**APPLICATION FOR PERMISSION
UNDER SECTION 16 OF
THE TOWN PLANNING ORDINANCE
(CAP.131)**

For Official Use Only 請勿填寫此欄	Application No. 申請編號	A19L-NTM / 453
	Date Received 收到日期	23 NOV 2022

(a) Proposed
use(s)/development
擬議用途/發展Temporary wholesale trade (electronic goods) and storage
with ancillary office for a period of 3 years

**Supplementary Planning Statement for Temporary Wholesale Trade
(Electronic Goods) and Storage with Ancillary Office for a Period of 3 Years
at Lots 2385 (Part) and 2400 (Part) in D.D. 102, Ngau Tam Mei, Yuen Long, N.T.**

**Proposed Layout Plan
(Revised on 4.1.2023)**

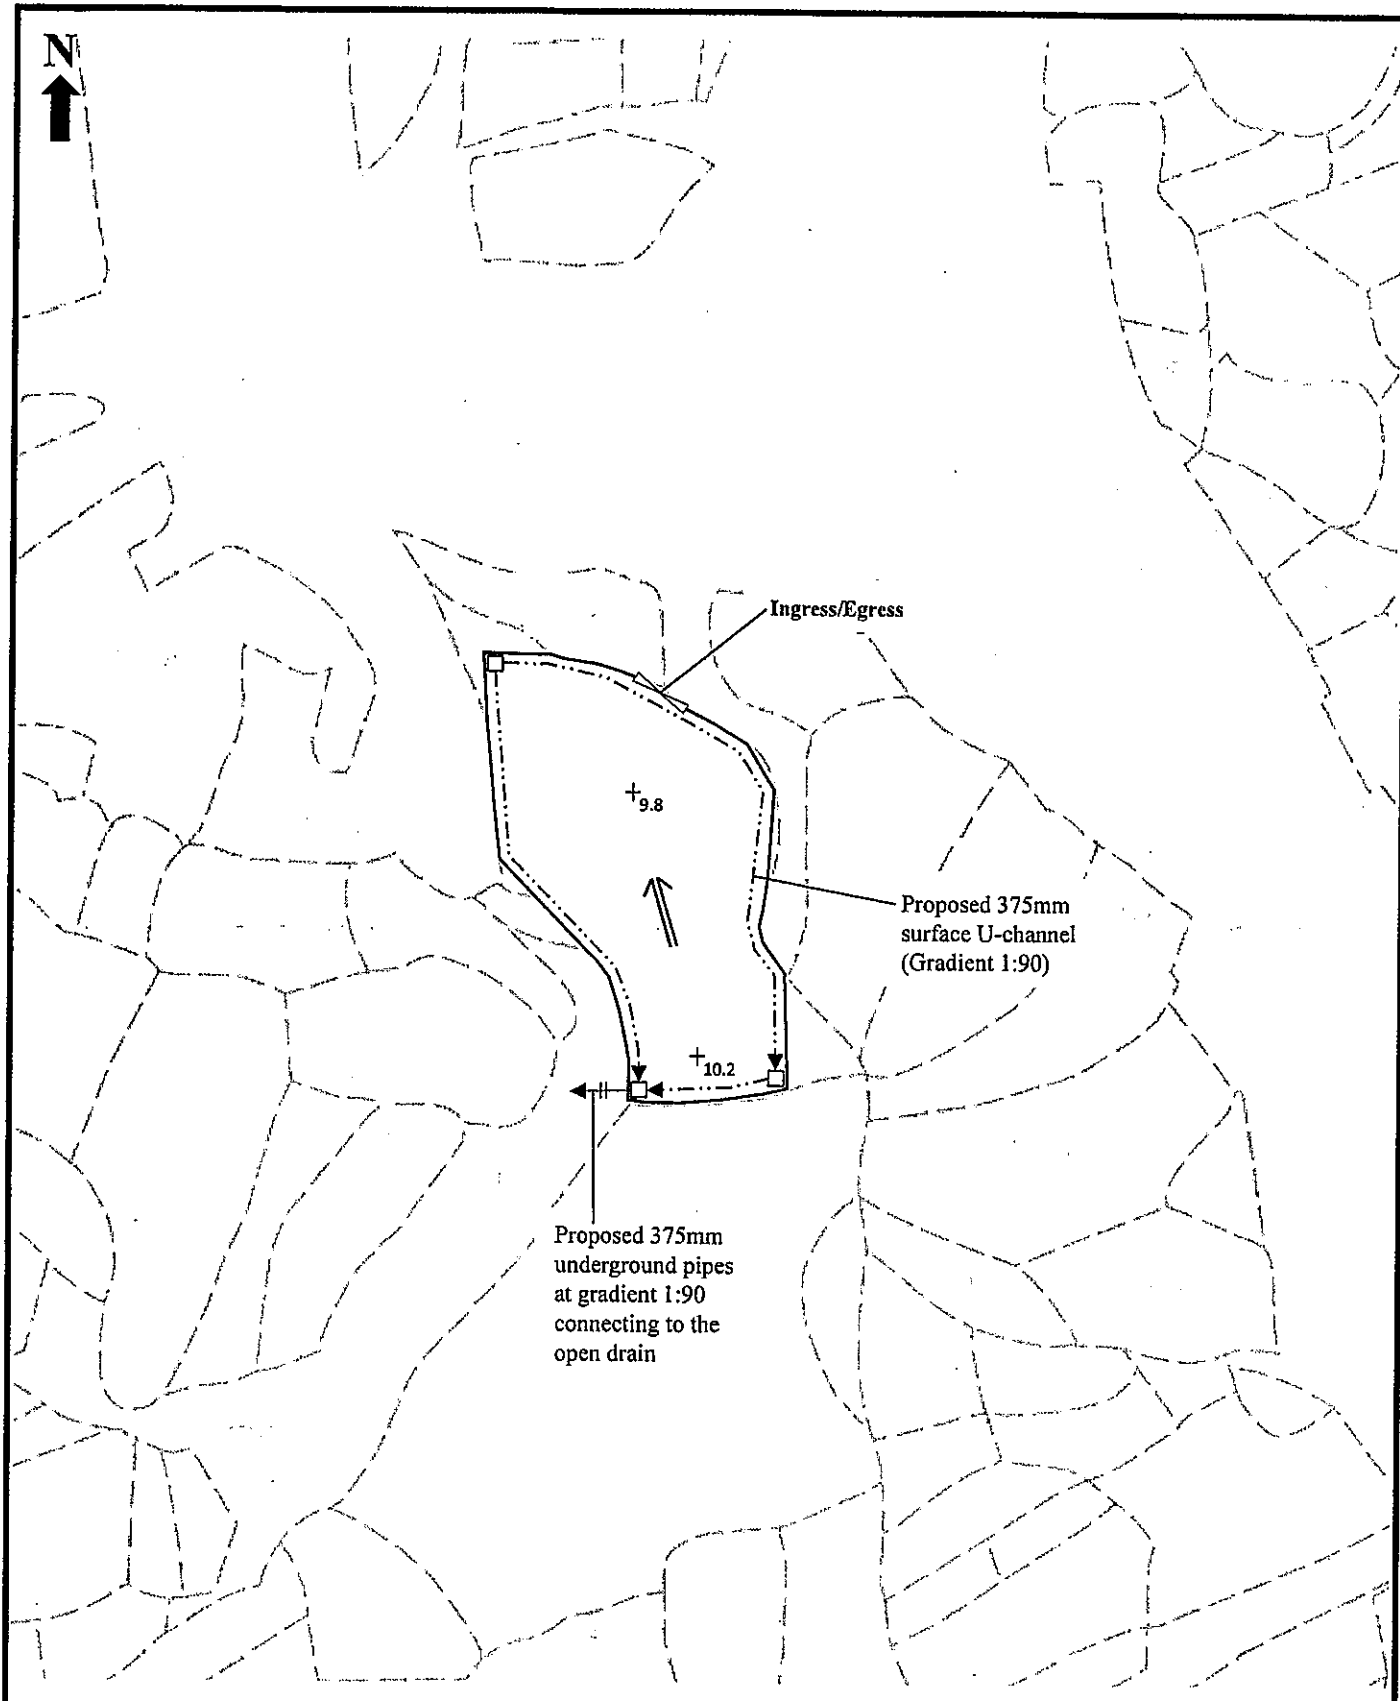
(a) TD's comments: The applicant should also provide trip attraction and generation rates at peak hours;

Noted. The width of the ingress and egress is 8 meters. Replacement pages for Figure 3 of supplementary planning statement is attached for your consideration.
